REMARKS

TITLE: METHOD AND APPARATUS OF INTERPOSING
VOLTAGE REFERENCE TRACES BETWEEN SIGNAL
TRACES IN SEMICONDUCTOR DEVICES
Serial No.: 09/548,942
Docket No.: 2269-4161US
ANNOTATED SHEET SHOWING CHANGES

Fig. 11

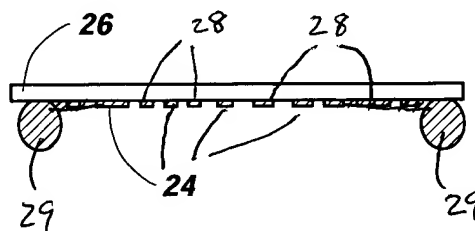
Fig. 11 has been modified to show the solder balls being connected to at least one signal and at least connected to the voltage reference signal, as suggested by the Examiner.

“[t]he specification needs to provide an explicit description with respect to the FIG. 11 embodiment of the connection of the solder balls to at least one signal trace and the voltage reference signal as recited in amended claims 24 and 31. Since this amended limitation is considered not to be “new matter,” then an amendment to the fig. 11 adding the amended claim limitation would be appropriate.”

The attached sheet of drawings includes changes to FIG. 11. This sheet, which includes FIGS. 6-11, replaces the previous drawing sheet including FIGS. 6-11. In FIG. 11, the solder balls are shown as being connected to at least one signal and at least connected to the voltage reference signal, as suggested by the Examiner. (See attached Replacement Sheet and Annotated Sheet Showing Changes.)
